DEPARTMENT OF PLANNING
STAFF REPORT

PLANNING COMMISSION PUBLIC HEARING

DATE OF HEARING: July 16, 2007

**SPEX 2006-0044 & CMPT 2006-0009, LOUDOUN COUNTY SCHOOLS – GRUBB
PROPERTY**

**GRAPHIC 2: EXISTING SCHOOL SITES -
WESTERN LOUDOUN**

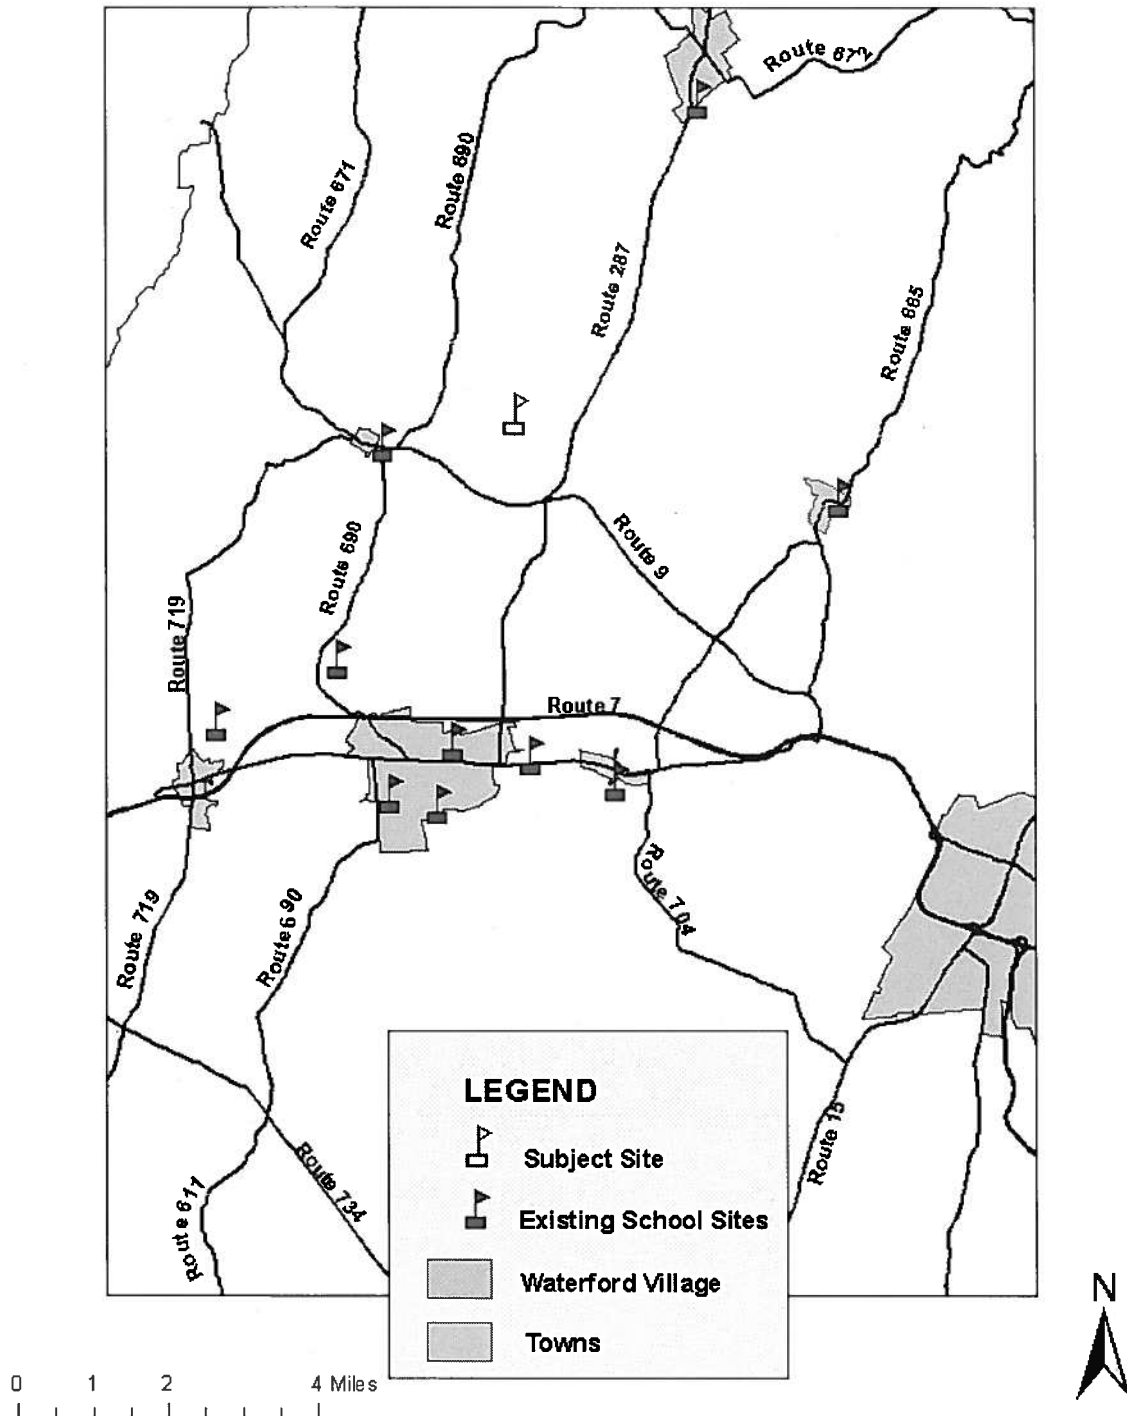
The historical development pattern for school sites has, for the most part, followed plan policies related to the County's growth management strategy - in particular plan policies that call for new school sites located within or adjacent to Towns, Villages or Joint Land Management Areas. Graphic 1, provided by Loudoun County Public Schools, demonstrates the subject property as being 3.5 miles from the Town of Hillsboro and 5.3 miles from the Town of Lovettsville. Graphic 2 on the other hand, which shows the location of existing schools within LCPS's Loudoun Valley Cluster and their relationship to the County's Towns and Villages, demonstrates Loudoun County's historical adherence to county plan policies for the location of new school facilities³.

It is not clear to staff the type of planning process that was undertaken by LCPS, the additional sites evaluated, and the sets of criteria used for each new school facility, which determined no site was available that could meet plan policies. Although LCPS stated they undertook an extensive search of land for the western high school site at Fields Farm (SPEX 2006-0022), staff notes that locational criteria used by LCPS for high school facilities may differ from those used for new elementary and middle schools. For example, the minimal acreage required for an elementary school may be smaller than that required for a high school.

An alternative site or sites should be identified that meet plan policies. If it is determined through a joint planning process between LCPS and the County that no suitable sites for schools can meet existing plan policies, then a re-evaluation of those policies may be necessary in the context of a Comprehensive Plan Amendment.

Graphic 4: Intersections and Road Segments Analyzed

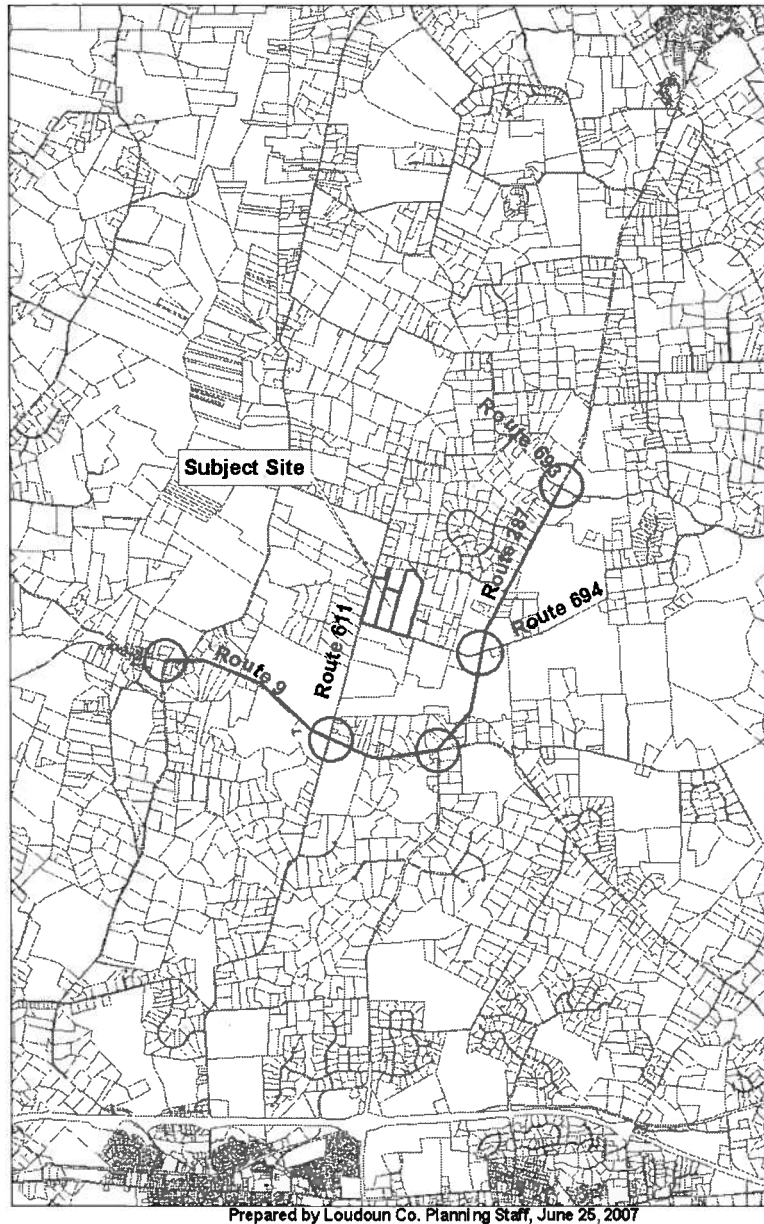
Staff notes that several improvements related solely to background traffic were identified in the TIA. LCPS has stated that they are not responsible for roadway improvements related to background traffic. Based on 2006 background traffic, the TIA identified unacceptable LOS at two signalized intersections along the Route 9 corridor. A LOS F for northbound movements at the a.m. and p.m. peak hours was identified at the intersection of Routes 9 and 690 along with LOS E and F for northbound and southbound traffic, respectively, for both peak hours at the intersection of Routes 9 and 287. Background traffic improvements, attributed to the 4% annual growth rate and consistent with the analysis years, are summarized in Table 1 below.

The TIA also estimated at 2012, the majority of ES-25 traffic entering the site from Route 287 will come from the north (45%) and from the west via Route 9 (40%). At 2022, the majority of MS-10 traffic entering the site from Route 287 will come from the north (35%) and from the east via Route 9 (30%). MS-10 traffic entering the site from Route 611 will come from the north (15%) and the west via Route 9 (15%). At this time, it is expected that the aforementioned 40% of ES-25 traffic entering the site from the west via Route 9 will be diverted from Route 287 to Route 611.

Based on the results of the TIA, the Virginia Department of Transportation, the Office of Transportation Services, and LCPS have agreed to phased roadway improvements to provide safe and adequate access to serve the two school facilities. Based on staff's comments, LCPS moved the proposed John Wolford entrance to the subject site further to the north to provide greater separation between the school entrance and the entrance to an existing single family home to the south. LCPS notes that the spacing distance meets

VDOT standards while providing safe and adequate access to the site. LCPS also agreed to provide a cul-de-sac at the northern terminus of existing Route 694. For Route 611, LCPS agreed to extend the paving from the proposed entrance to the boundary of the northern property line and to limit access to the site from Route 611 to emergency access only until all road improvements are completed prior to the opening of MS-10. LCPS verified that Routes 694 and 611 will need to be upgraded to incorporate 11 foot asphalt travel lanes, with appropriate ditch and shoulder improvements, and in accordance with VDOT standards. While LCPS believes that these roadway improvements can be accomplished within a 40 foot right-of-way (ROW), LCPS has agreed to provide any additional ROW and/or easements as necessary to accommodate the improvements. Finally, LCPS has agreed to provide signals when warranted at the Route 9 @ Route 611 intersection and the Route 287 @ Route 694 intersection, contingent upon VDOT approval.
